Correcting 4 False Assumptions
in PG&E's Seismic Source Characterization [2015]
and Update [2024] that Caused PG&E to
**Seriously Underestimate Seismic Hazard
at Diablo Canyon Nuclear Power Plant**

2024.07.17 presentation to the Petition Review Board of the
U.S. Nuclear Regulatory Commission

by Peter Bird, Professor Emeritus, UCLA
consulting to San Luis Obispo Mothers for Peace,
Friends of the Earth, & Environmental Working Group

Basemap excerpted from Plate 7-1 of Pacific Gas & Electric (2015) Seismic Source Characterization for Diablo Canyon Power Plant; Inferred Coastline thrust fault trace (in red) added by P. Bird, 2024.06.19. Triangle symbols show direction of dip of thrust faults.

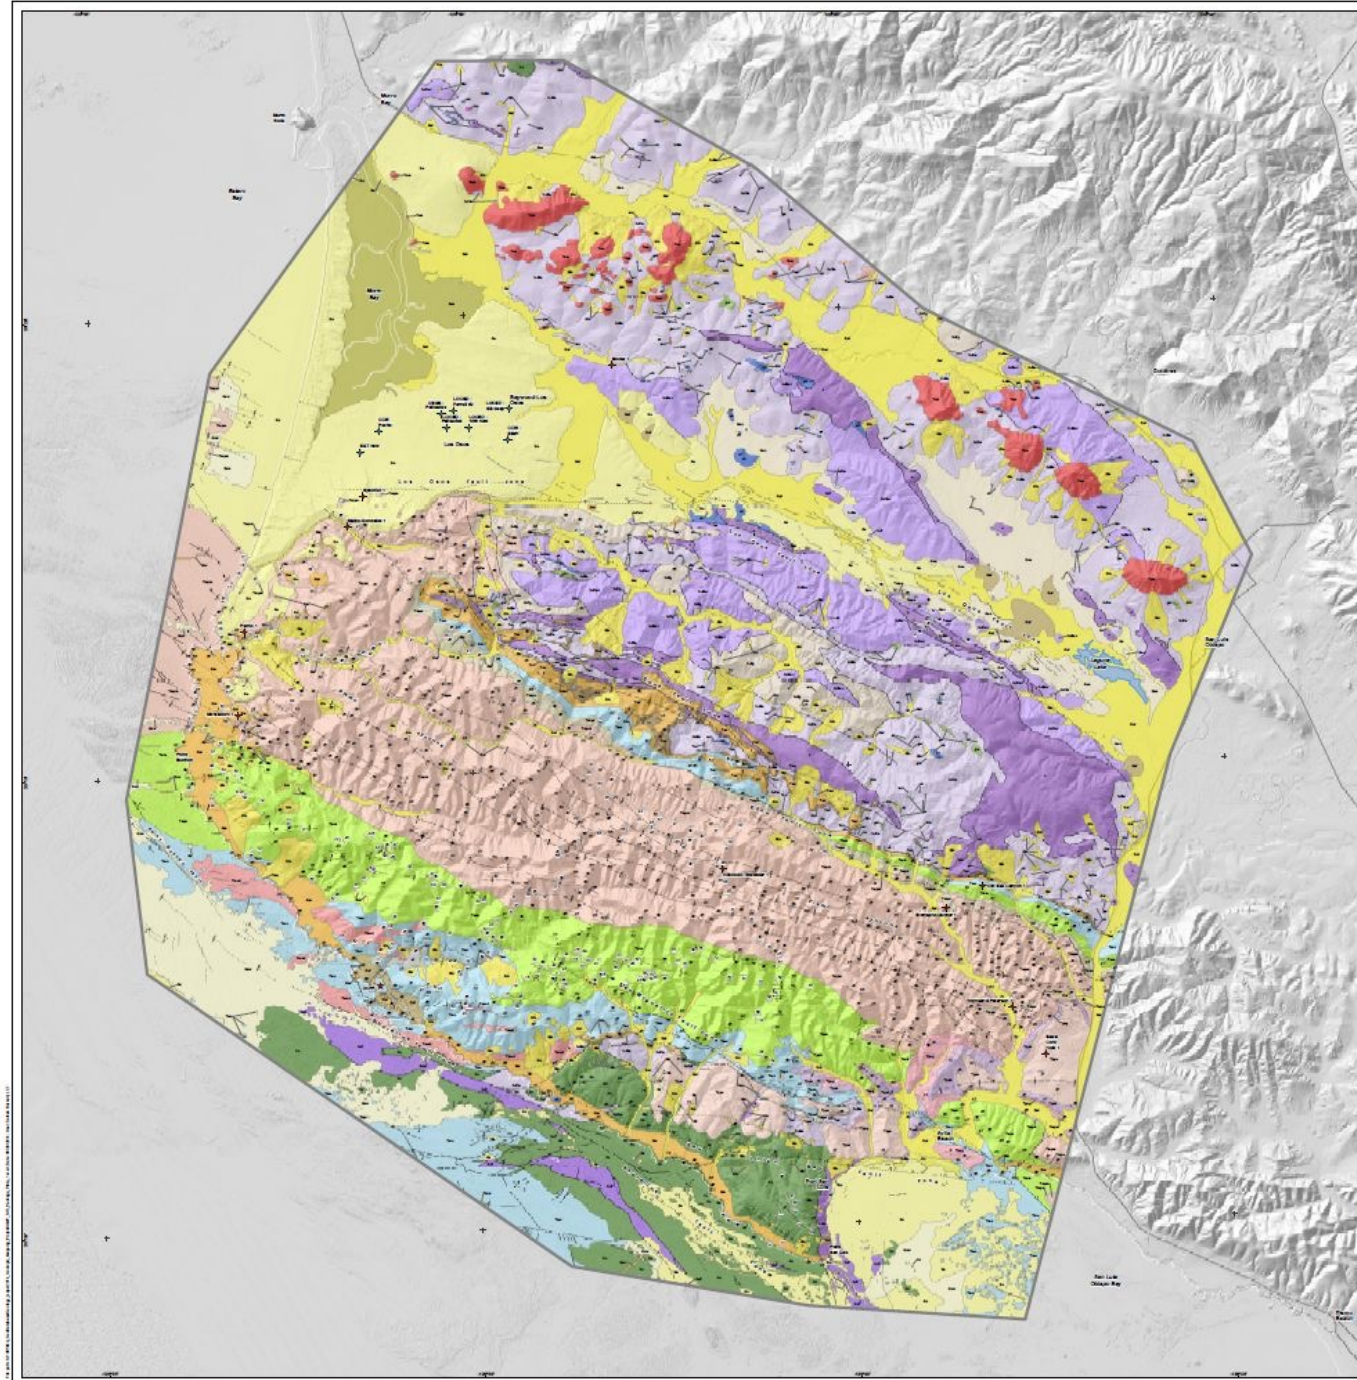
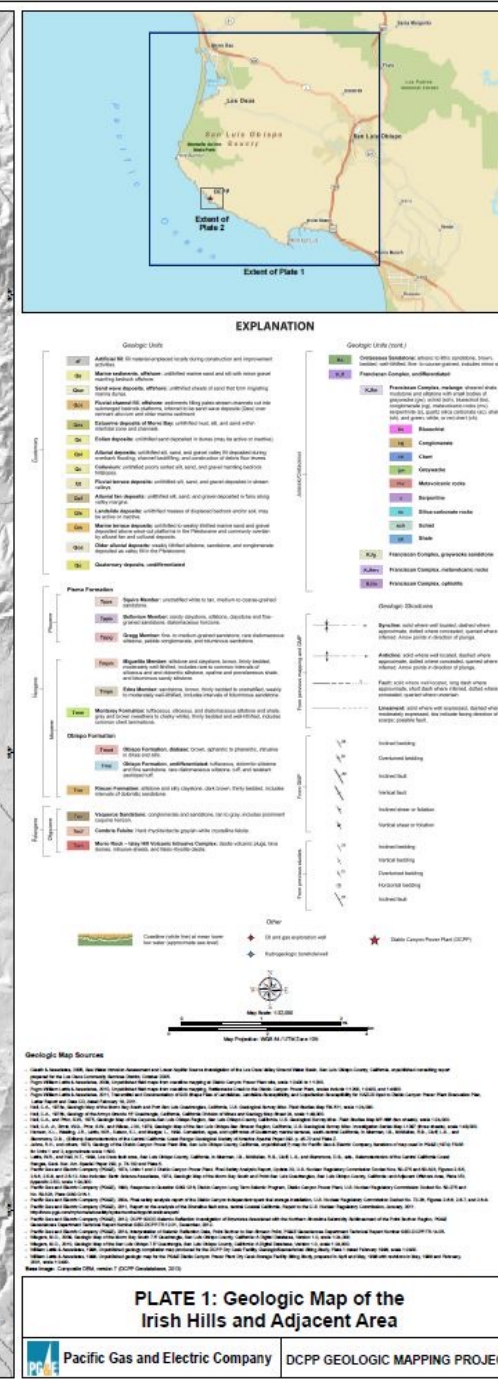
#1. The Irish Hills are uplifting (at ~0.2 mm/year, stipulated) as a rigid block, with no internal deformation.

Therefore, thrust faulting occurs only at the margins (Los Osos thrust, San Luis Bay thrust, **?Inferred Coastline thrust?**) with fault throw (vertical) rates of ~0.2 mm/year.

- The geologic map shows tight folding of Late Miocene sedimentary rocks has occurred since 6~5 Ma. Therefore, the Irish Hills are not rigid, and additional blind thrust faults are active in the interior.
- Rigid-body uplift does not produce crustal thickening. Therefore, if the Irish Hills were a rigid block, they would have a positive isostatic gravity anomaly. However, data shows a negative isostatic gravity anomaly, indicating more than simple Airy compensation by crustal roots (more than the typical Airy ratio of 6:1).

The geologic map of the Irish Hills demonstrates large internal deformation since 5 Ma, especially in the Pismo Syncline.

$$(0.2 \text{ mm/year uplift}) \times 6 / \sin(25^\circ \text{ dips}) = 2.8 \text{ mm/year}$$

Figure 6-2. Large-Scale Residual Isostatic Gravity Anomaly Map Showing a Negative Gravity Anomaly Coincident with the Irish Hills (modified from Langenheim et al., 2008 and PG&E, 2011, Figure E-2)

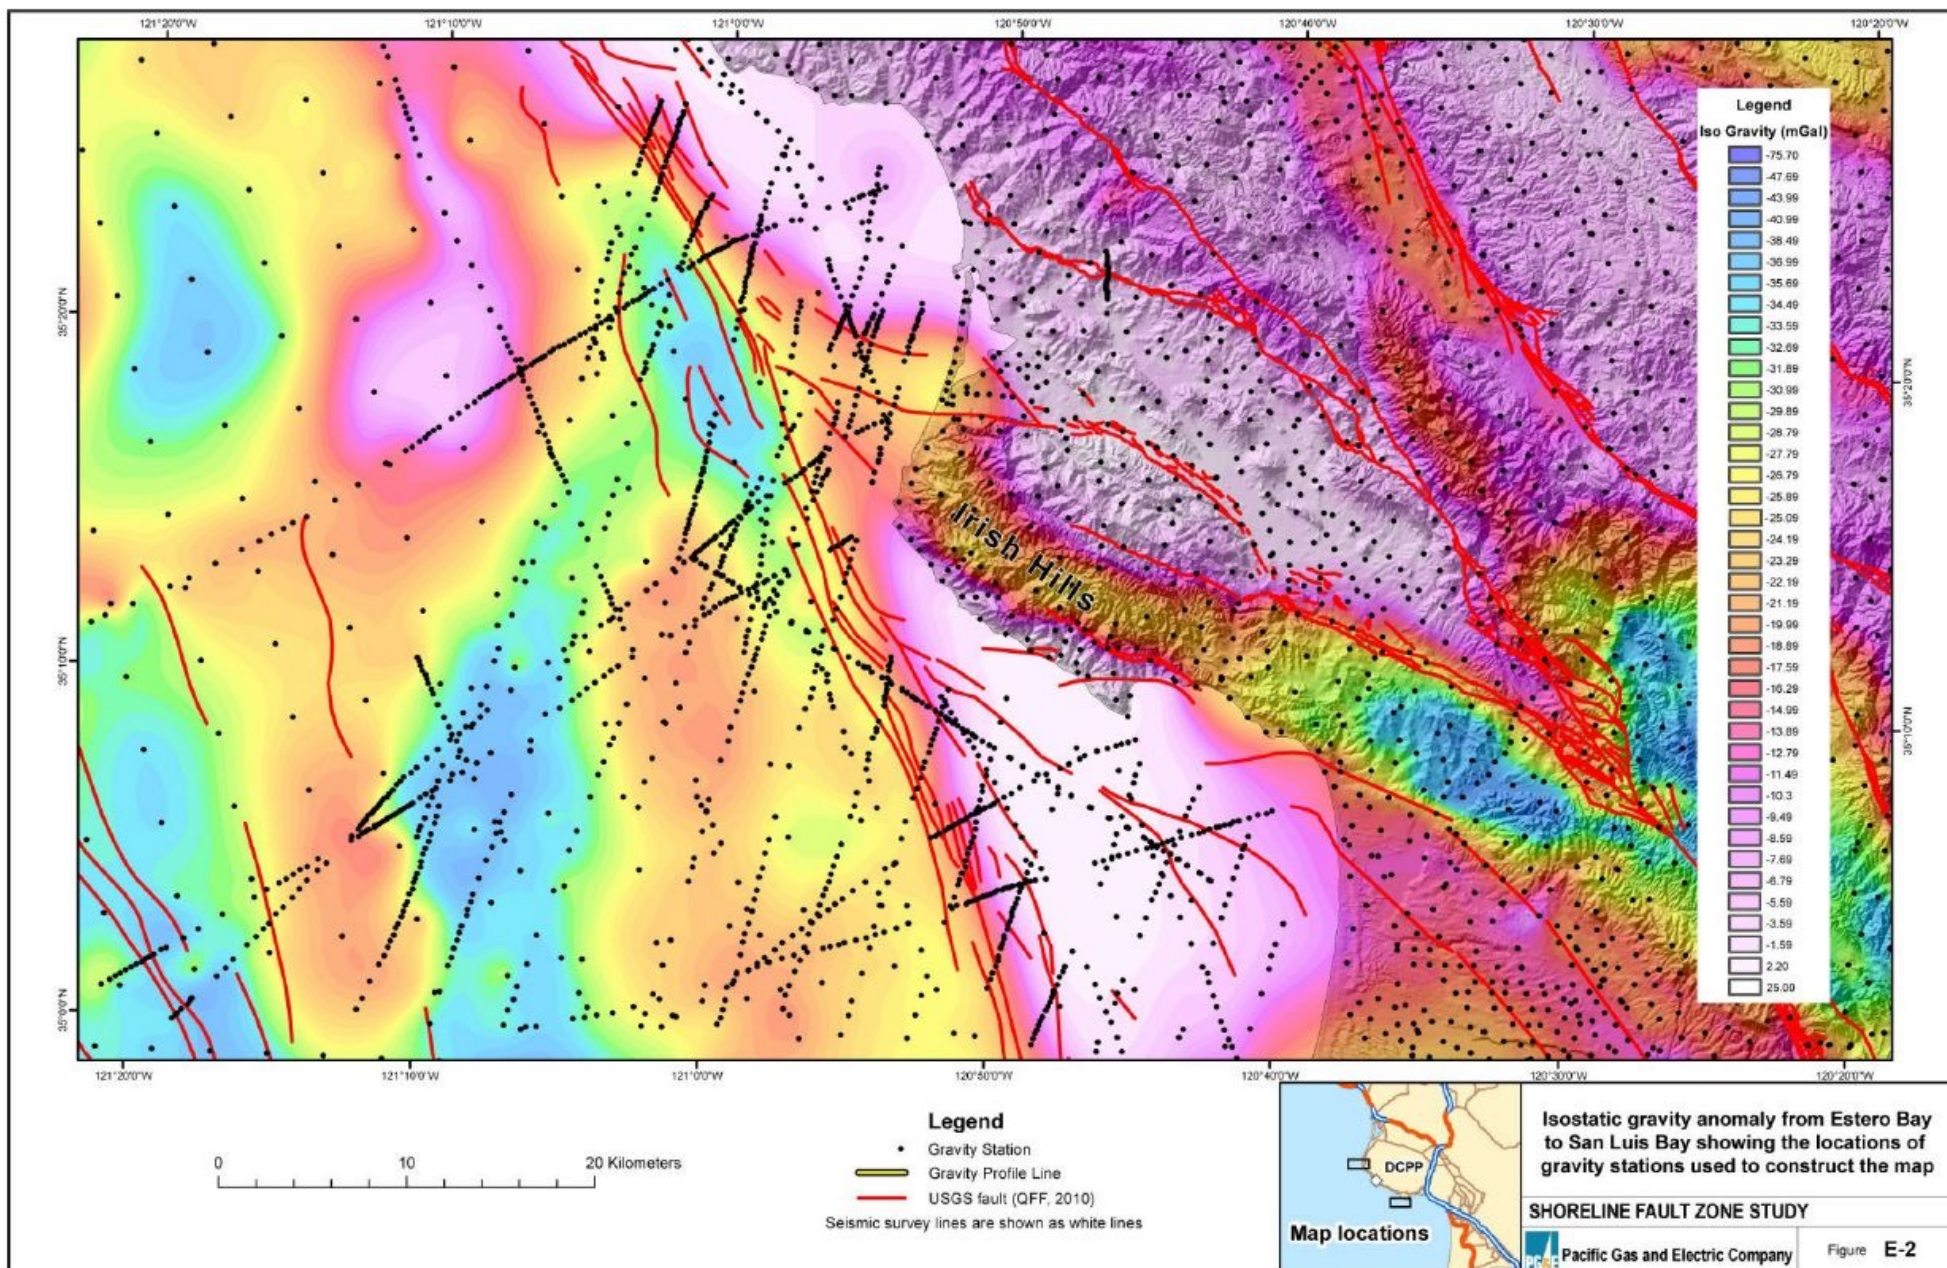
➤ Rigid-body uplift does not produce crustal thickening. Therefore, if the Irish Hills were a rigid block, they would have a positive isostatic gravity anomaly. However, data shows a negative isostatic gravity anomaly, indicating more than simple Airy compensation by crustal roots (more than the typical Airy ratio of 6:1).

The negative isostatic gravity anomaly here means that:

The topography of the Irish Hills is not just isostatically compensated, it is OVER-compensated by crustal thickening.

$$(0.2 \text{ mm/year uplift}) \times 6 / \sin(25^\circ \text{ dips}) = 2.8 \text{ mm/year}$$

Figure 5
Shear stress plotted as a function of normal stress at the maximum friction for a variety of rock types at normal stresses to 1000 bars.

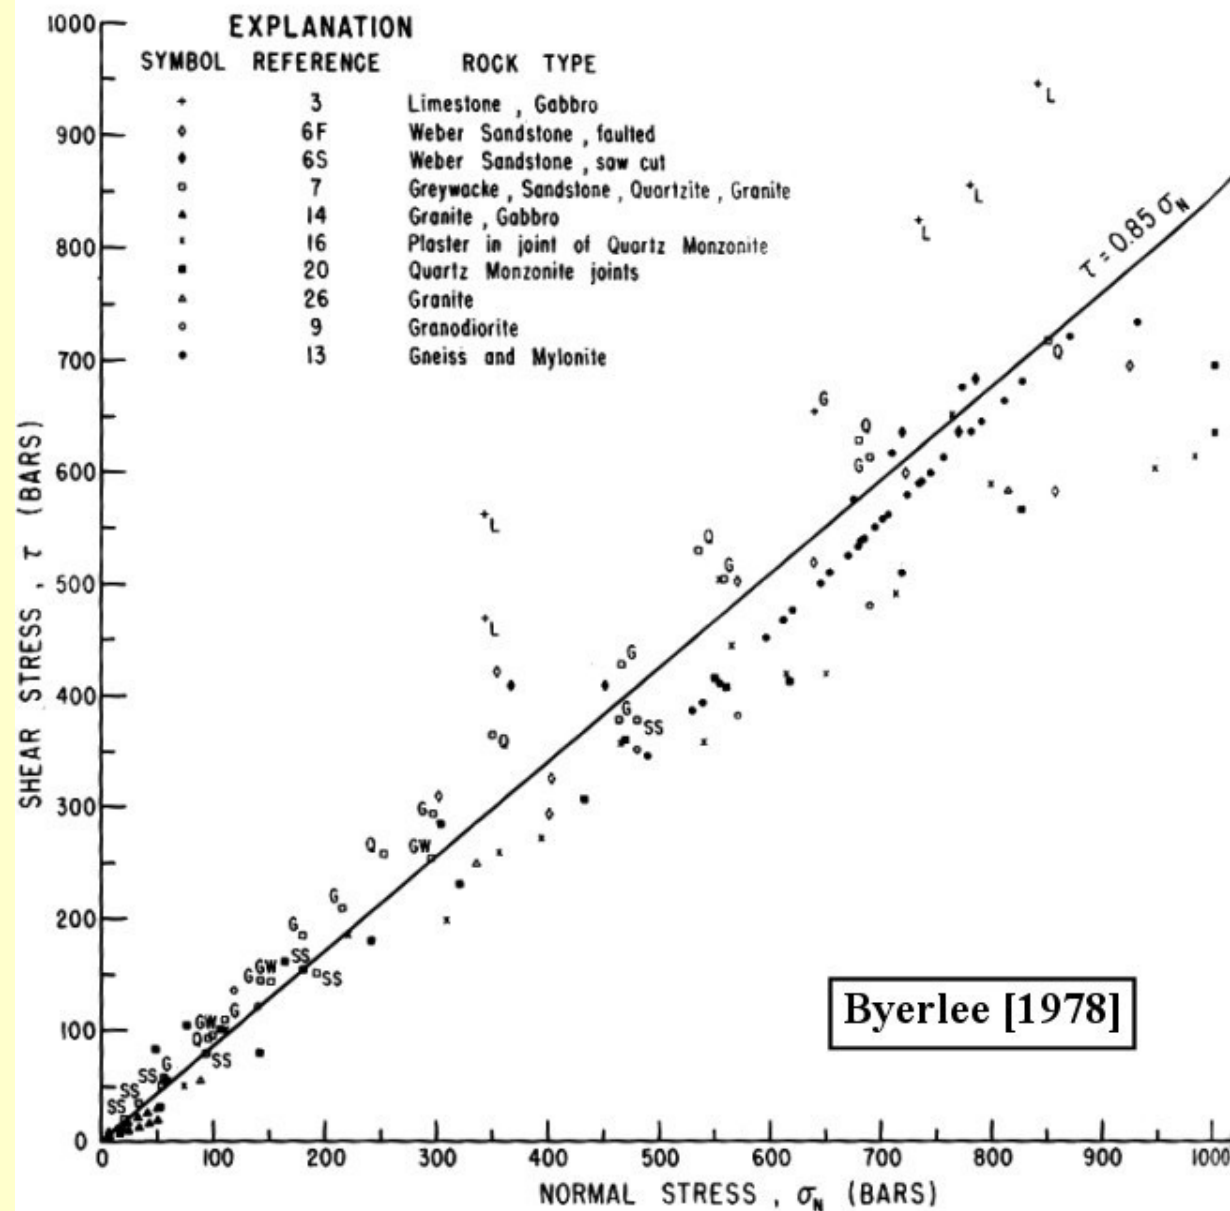
125-year-old Mohr/Coulomb friction theory shows that thrusts never form at dips steeper than 45°, and most commonly dip at ~25° [for rock friction coefficient of 0.85; *Byerlee*, 1978].

Compared to reasonable estimates (obtained with dip of 25°), an assignment of 50° dip reduces seismic potency rate by a factor of **3.3×**. An assignment of 80° dip reduces seismic potency rate by factor of **5.4×**.

Thus, PG&E underestimated seismic potency of these 2 thrusts (which were the only ones they recognized) by large factors.

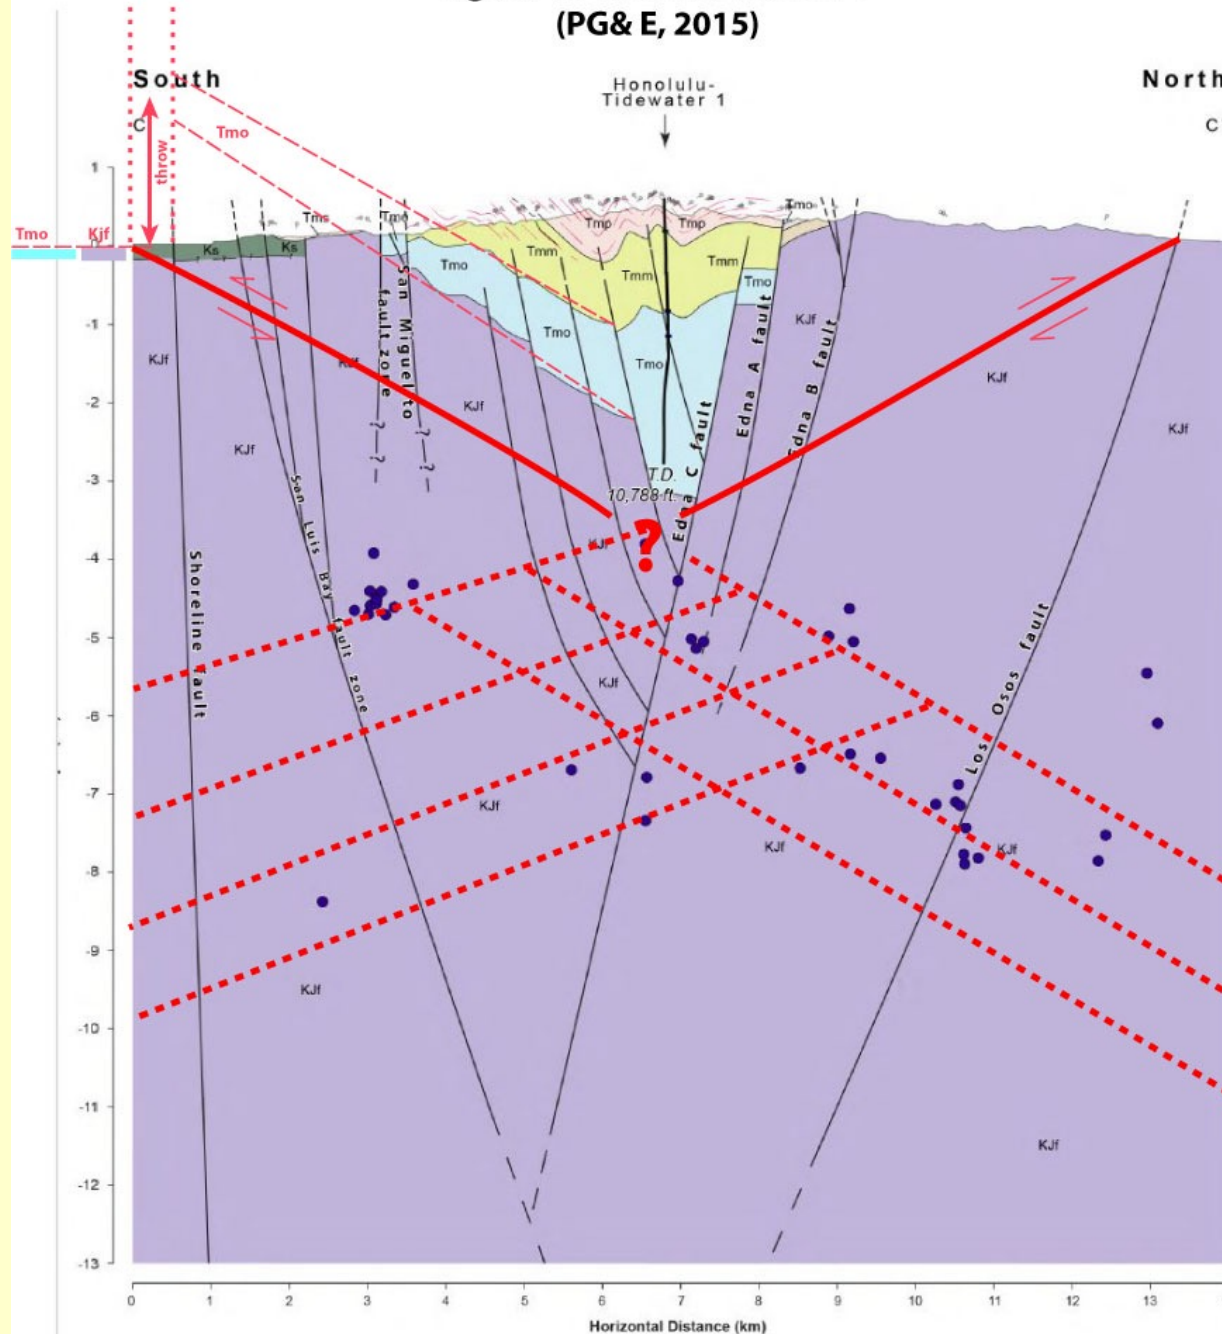
I provided one example in Figure 1 of my March 2024 Declaration: Throw of the Obispo Formation at the San Luis Bay-Inferred Coastline thrust fault is 1.6~2.2 km since 5 Ma, implying throw-rate of 0.32~0.44 mm/year, and fault slip rate of 0.76~1.04 mm/year.

Mark-up (in red) by P. Bird, 2023 of

Figure 13-17 of SSC for DCPD
(PG&E, 2015)

If thrusting in the Irish Hills has been symmetrical(?), then a minimum total thrust slip-rate by this method would be 1.52~2.08 mm/year. (However, this neglects any internal blind thrusts.)
